Service Bulletin

Bulletin No.: 17-NA-233

Subject: Malfunction Indicator Lamp (MIL) Illuminated - DTC P0446 Set

Brand:	Model:	Model Year:		VIN:		Engine:	Transmission:
		from	to	from	to		
Chevrolet	Cruze	2016	2019			1.4L (LE2)

4224572

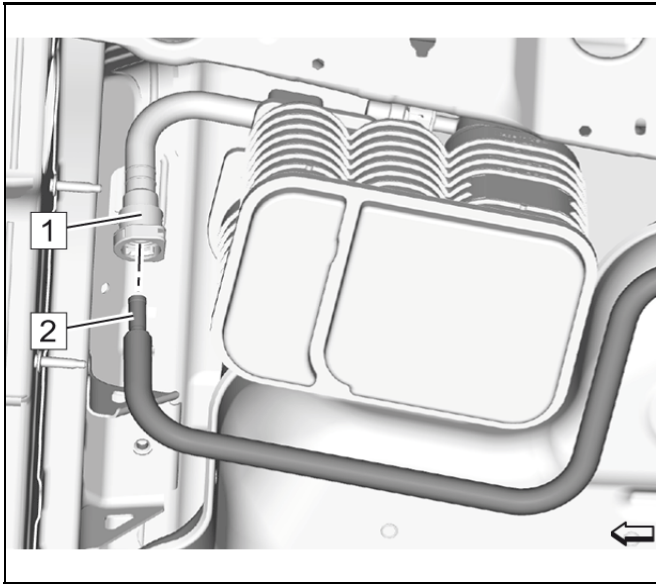
3. Using care, separate the evaporative emission canister filter pipe assembly retainers (2) from the vehicle and remove the assembly.

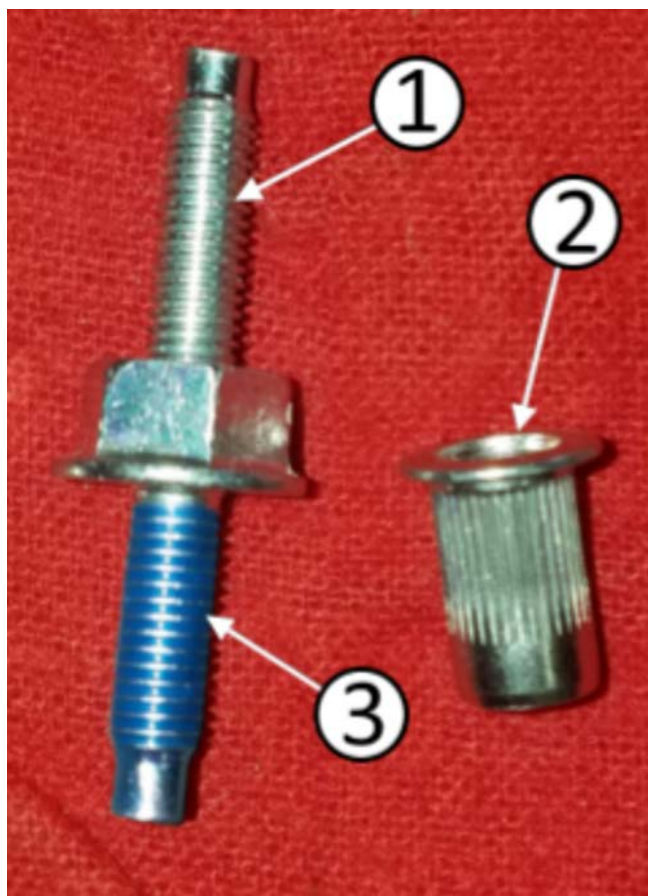
5. Install the new evaporative emission canister filter pipe (1), attaching the two lower clips to the existing studs (2).
6. Connect the evaporative emission canister filter pipe to the evaporative emission canister.
